SUBJECT: PALISADES PLANT - AMENDMENT NO. 143 TO FACILITY OPERATING LICENSE
NO. DPR-20 (TAC NO. M82059)

AMENDMENT NO.143 TO FACILITY OPERATING LICENSE NO. DPR-20-PALISADES

ATTACHMENT TO LICENSE AMENDMENT NO. 143

SAFETY EVALUATION BY THE OFFICE OF NUCLEAR REACTOR REGULATION

FIGURE 3-0

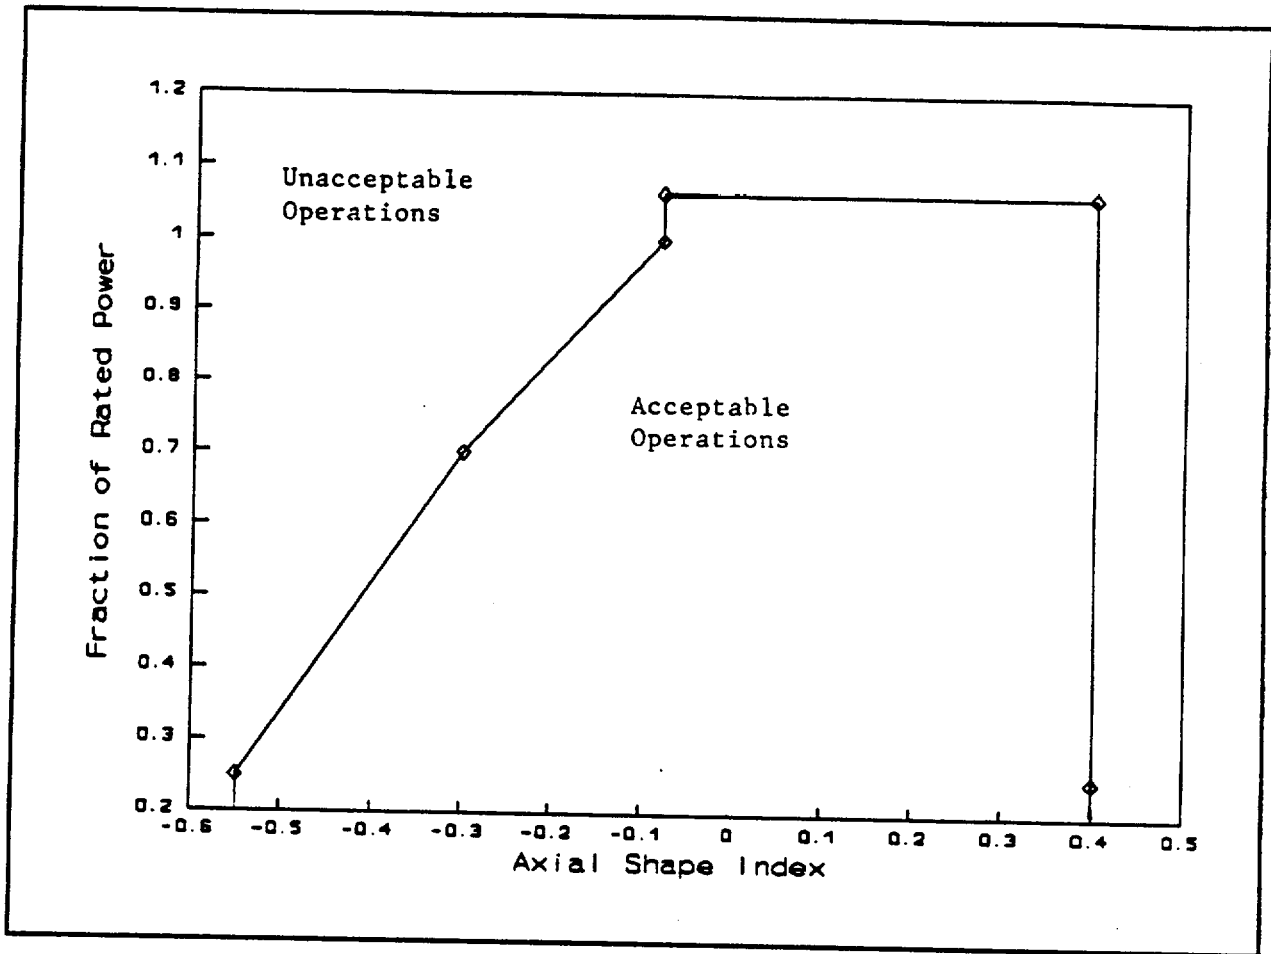
The Axial Shape Index alarm channel is being used to monitor the ASI to ensure that the assumed axial power profiles used in the development of the inlet temperature LCO bound measured axial power profiles. The signal representing core power (Q) is the auctioneered higher of the neutron flux power and the Delta-T power. The measured ASI calculated from the excore detector signals and adjusted for shape annealing (Y_1) and the core power constitute an ordered pair (Q, Y_1). An alarm signal is activated before the ordered pair exceed the boundaries specified in Figure 3.0.

ASI Limit for T_{inlet} function

- 0.550, 0.250
- 0.300, 0.700
- 0.080, 1.000
- 0.080, 1.065
- +0.400, 1.065
- +0.400, 0.250
